Substantive response of the Local Highway Authority to a planning consultation received under The Development Management Order.

Planning Application Number: 24/00560/HYB

Application Address: Land Off Station Road Market Bosworth Leicestershire

Description of Application: Re-consultation. Hybrid planning application seeking full planning permission for residential development of 138 dwellinghouses along with landscaping, public open space, drainage infrastructure and new access following demolition of two existing dwellinghouses; and outline planning permission (all matters reserved except for point of access) for 0.55ha of employment uses (Classes E (g) (i, ii and iii), B2 and B8)

Figure 1: Applicant's study area reproduced from the Transport Assessment.

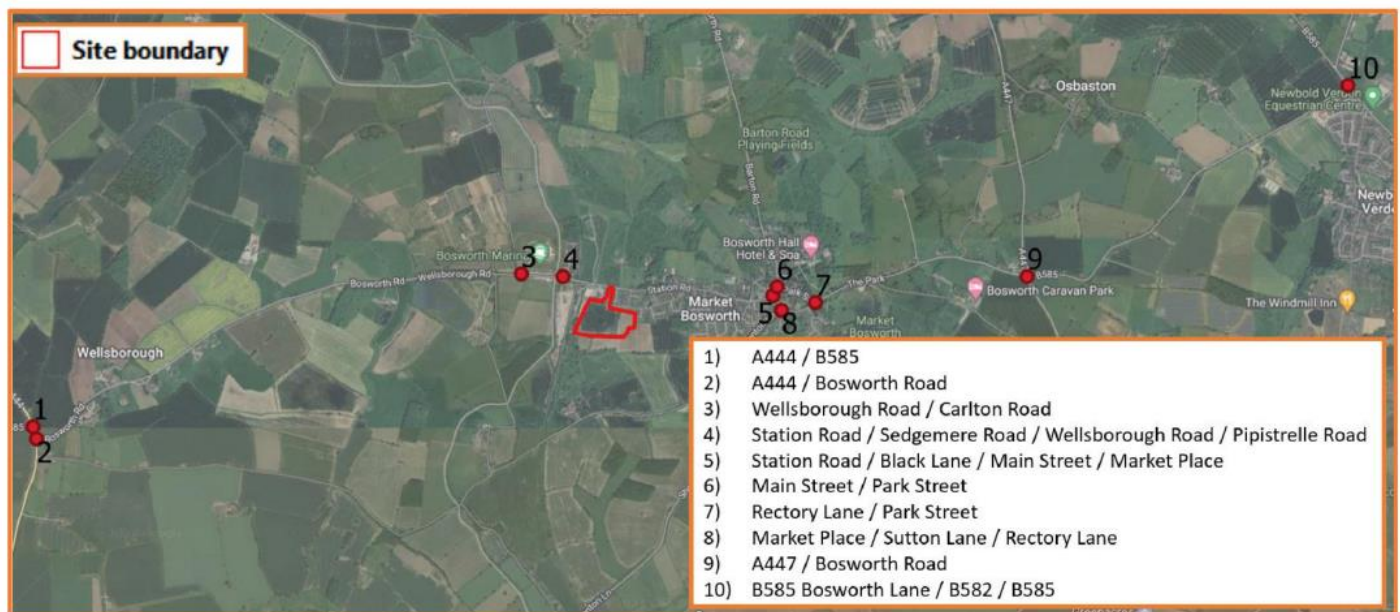
As previously advised, the Applicant's study area is shown in Figure 1. The study junctions are accepted by the LHA.

The LHA previously advised that in addition to considering the proposed road layout changes in the centre of Market Bosworth, the capacity assessments would need to consider application reference 24/00831/OUT within a sensitivity test. The Applicant has now amended traffic flows in this area and included application 24/00831/OUT within the 2029 background AM and PM peak flows (Diagrams 1 and 2 within the TN). Whilst that application has not been considered specifically as part of a sensitivity test, it has been considered as a committed development in the '2029 background year' scenario, under the site-specific circumstances, a revised capacity assessment is not considered necessary.
